**Project No. 35077**

**Amendment No. 1**

**Generation Interconnection Agreement**

## **FIRST AMENDMENT TO THE ERCOT STANDARD GENERATION INTERCONNECTION AGREEMENT**

One Line Diagram – TSP Interconnection Facilities, Generation Interconnection Facilities and the Plant

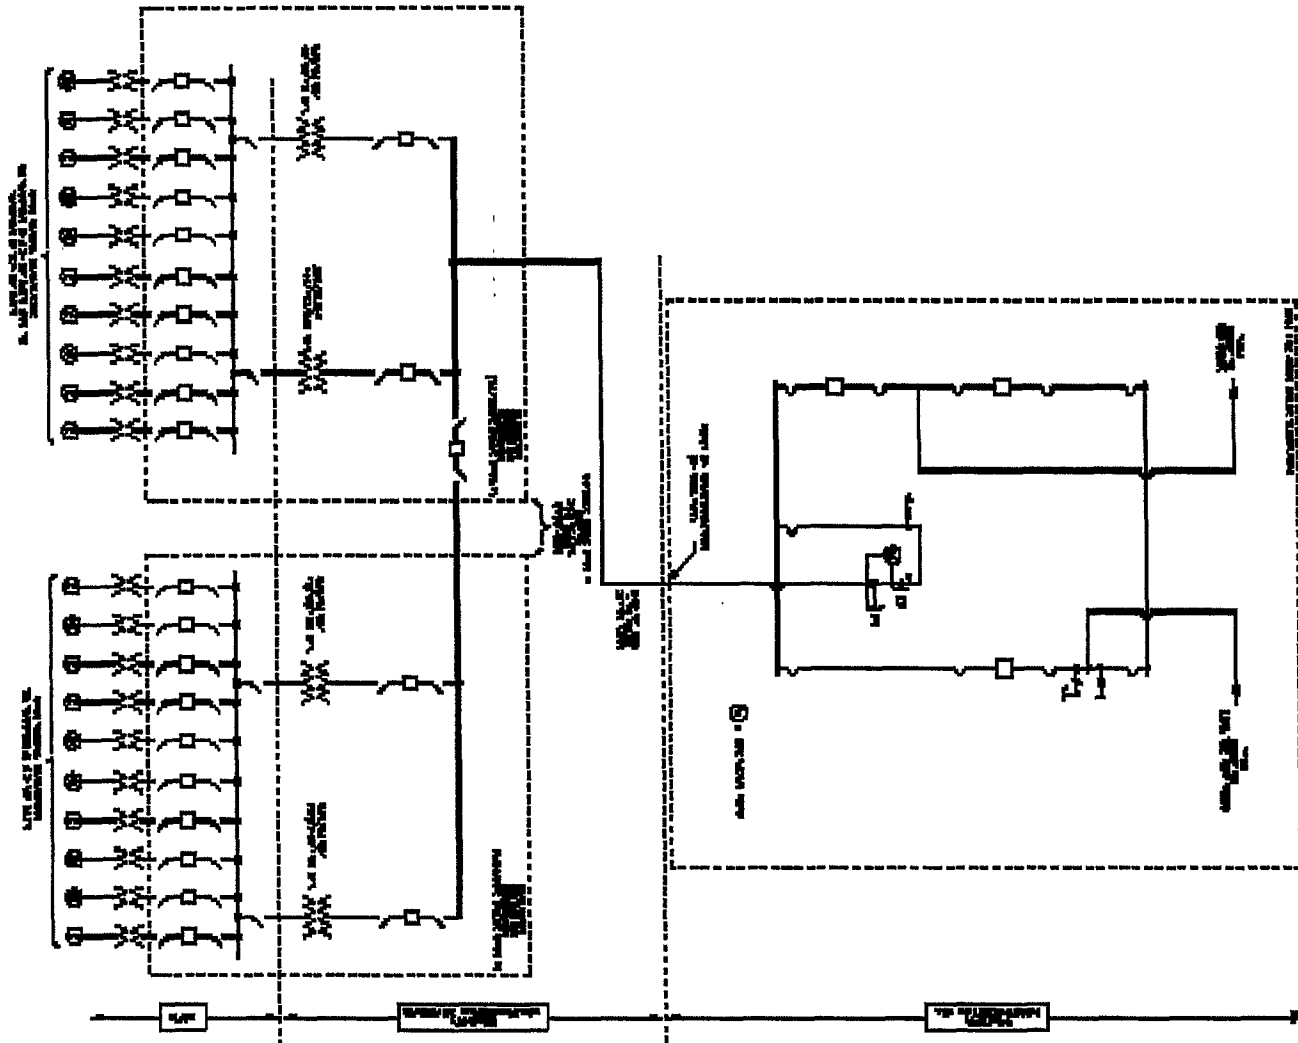
1. Exhibits "B", "C", "C1", "C2", "C3" and "E" are deleted in their entirety and Exhibits "B", "C", "C2", "C3" and "E" attached to this First Amendment are hereby added to the Agreement in lieu thereof.
2. Exhibits "B", "C", "C1", "C2", "C3" and "E" attached to this First Amendment will become effective upon execution of this First Amendment by the Parties.
